Response to MSG Sphere planning application

To The Planning Policy and Decisions Team,
London Legacy Development Corporation
In respect of Application Reference 19/00097/FUL
Date June 2019
Revised January 2020
Revised November 2020

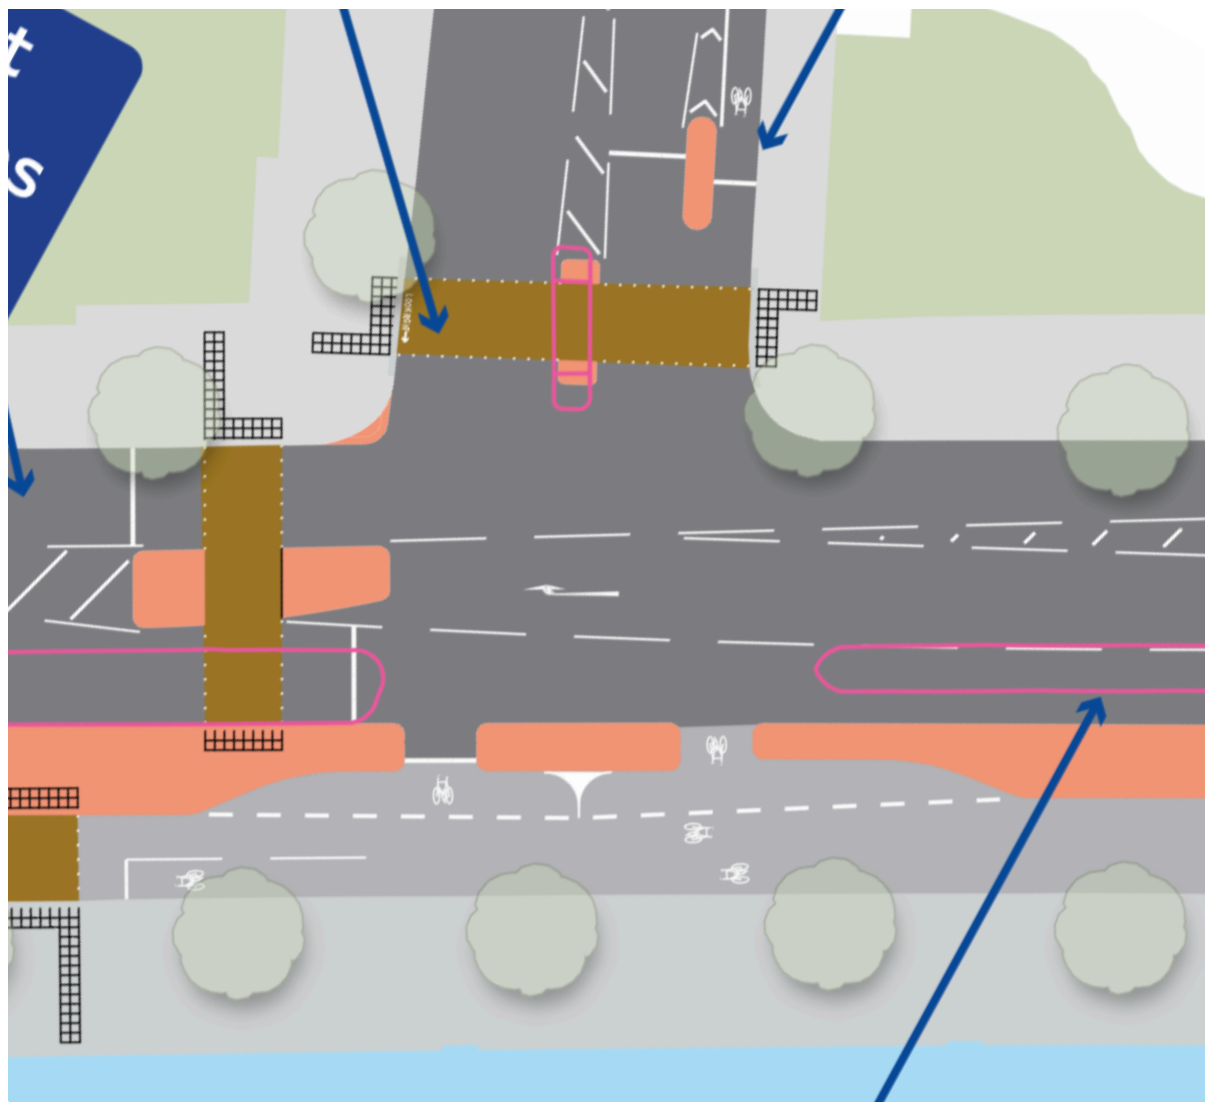
While we are pleased to see the minor revisions to the design, we are concerned that the designs proposed by the applicant are still not up to best practice in London, let alone internationally. They only treat a small section of Montfichet Road, and still give up with shared footway/cycleway treatments at the junctions and at the end of the road. Conflict between people walking and cycling is baked into the design. The design repeats of the mistakes of previous schemes in the Olympic Park.

We are also disappointed that there are no improvements proposed to the surrounding streets. International Way, Hitchcock Lane, Penny Brookes Street, and Celebration Avenue are crying out to be made safer for walking and cycling—which will become more urgent when high volumes of motorists travelling to the Sphere begin using these roads to access the car parks.

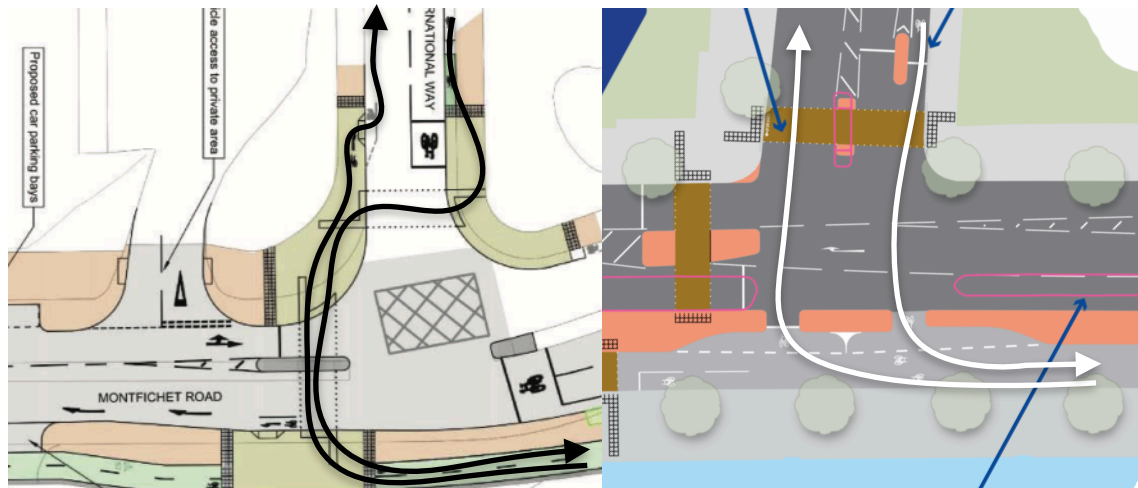
Above: A side-by-side comparison of the expected cycle movements on Montfichet Road/International Way (**left**) and Victoria Embankment/Horse Guards Road (**right**) for a cyclist leaving the cycle track by turning right, and joining the cycle track by turning left. Note that the Victoria Embankment example allows people to make a gentle, smooth turn, and does not require them to make sharp turns, mount the pavement, or double back on themselves.

Shared footways at junctions, as seen at the junctions with Hitchcock Way, International Way, and the existing poor quality shared footway infrastructure at Penny Brookes Street, is a sub-optimal and indirect solution that puts people walking and cycling in direct conflict with each other. People cycling are expected to swerve onto the pavement, wait at the pedestrian crossing, cross with pedestrians, and then (potentially) swerve back into the carriageway.

As with any shared area, this is inconvenient for people cycling and can be dangerous for people walking. It does not work when there are anything other than very low volumes of people cycling and walking. In practice, those cyclists willing to accept the risks will use the carriageway instead.

We want to see these junctions redesigned such that people cycling and walking do not have to share space when crossing, and instead have parallel crossings. Several examples of how to do this with a bi-directional cycleway can be found on East-West Cycle Superhighway (the central London section of Cycle Superhighway 3). The example we examine here is at the junction of Victoria Embankment and Horse Guards Road.

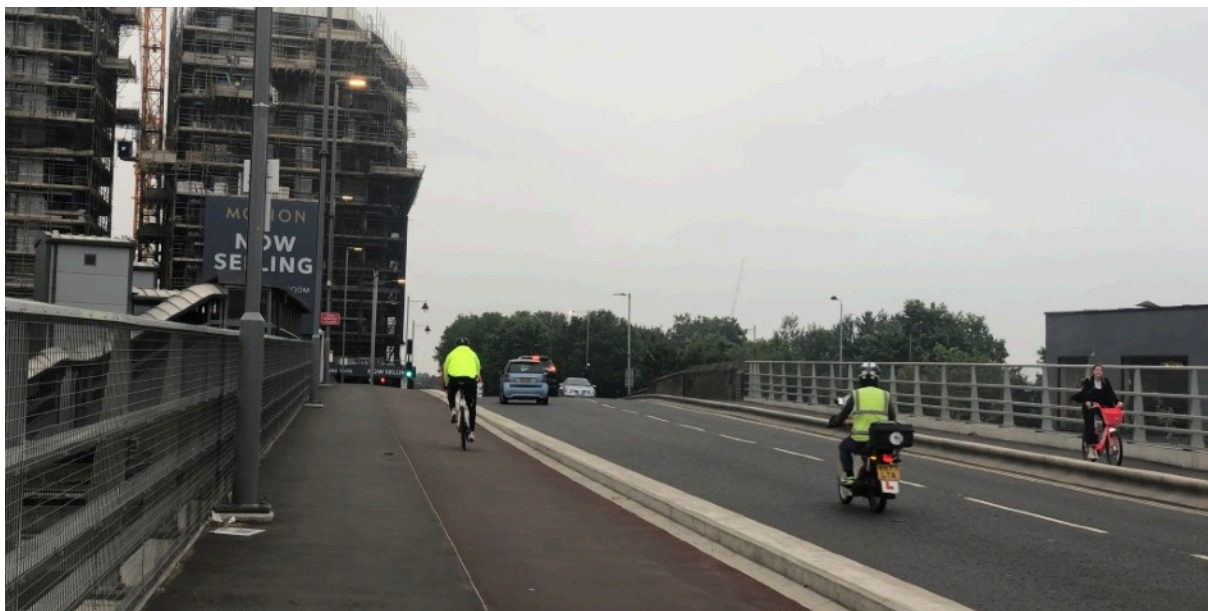
There are many documented examples of cases where riding in the centre of the lane is not enough to prevent dangerous overtakes or bullying from motorists.

- Some motorists believe (wrongly) that cyclists should always ride as close to the kerb as possible;
- Some motorists believe (wrongly) that people cycling do not pay towards the upkeep of the roads, and so have no right to use them;
- Some motorists are simply impatient.

It is not reasonable to expect people cycling to put up with motorists bullying them. We think it's also likely that this further excludes under-represented groups from cycling, particularly women and people of colour.
